**RE: Docket No. 23-38-EL – The Narragansett Electric Company d/b/a
Rhode Island Energy’s Petition for Acceleration of a System Modification
Due to Distributed Generation Project
Weaver Hill Projects
Responses to Division Data Requests – Set 2**

The Narragansett Electric Company
d/b/a Rhode Island Energy
RIPUC Docket No. 23-38-EL
In Re: Rhode Island Energy's Petition for Acceleration Due
To Distributed Generation Project – Weaver Hill Projects
Responses to the Division's Second Set of Data Requests
Issued on January 15, 2024

Figure 2-1-1 – 63F6 Loading After Power Factor Correction
(red indicates an overload)

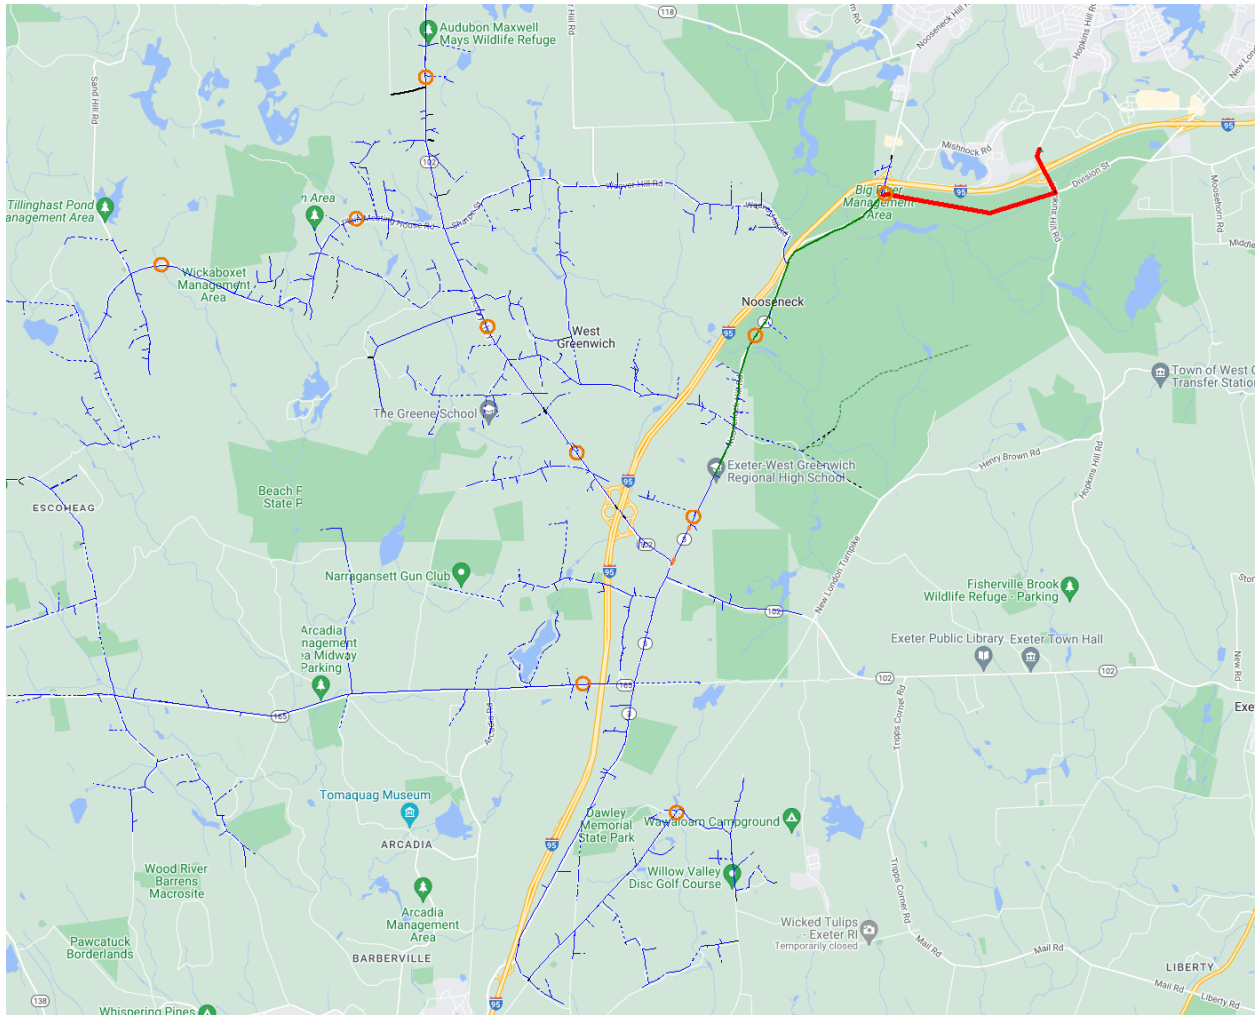
Provide a CYME model with the solution for the Coventry 54F1 and Hopkins Hill 63F6 thermal issues being solved by the application of capacitors for optimum power factor correction.

A CYME model is included at Attachment DIV 2-1 with the power factor corrected to near unity on the Coventry 54F1 and Hopkins Hill 63F6.

For the 63F6, five capacitor banks were added to the model. Voltage and loading issues remain after the addition of the capacitor banks as shown in Figure 2-1-1 and 2-1-2.

Figure 2-3-1 – 63F6 Section Loading Above 90%

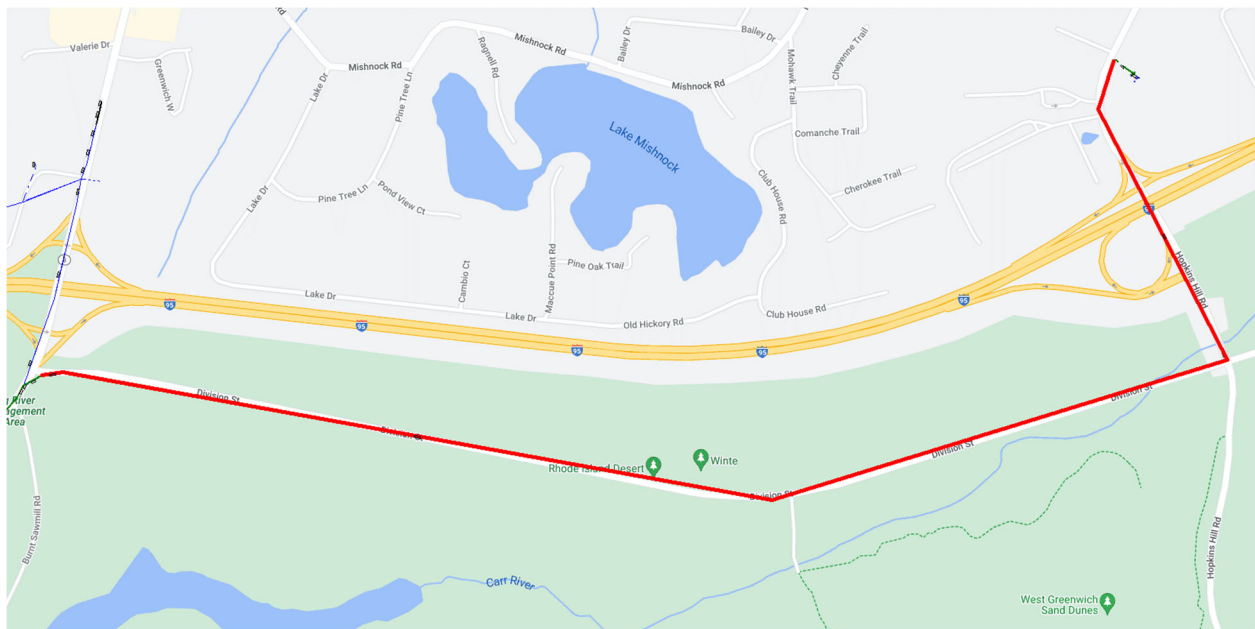
Show on a circuit diagram for Coventry 54F1 and for Hopkins Hill 63F6 the portion of the feeder which is overloaded or loaded beyond 90 percent. Include the conductor size and ampacity of the conductor being used for the calculations.

Figure 2-3-1 is a circuit diagram for Hopkins Hill 63F6 showing the portion of the feeder which is overloaded or loaded beyond 90 percent. The conductor is 477 aluminum spacer cable, rated for 530 amps.
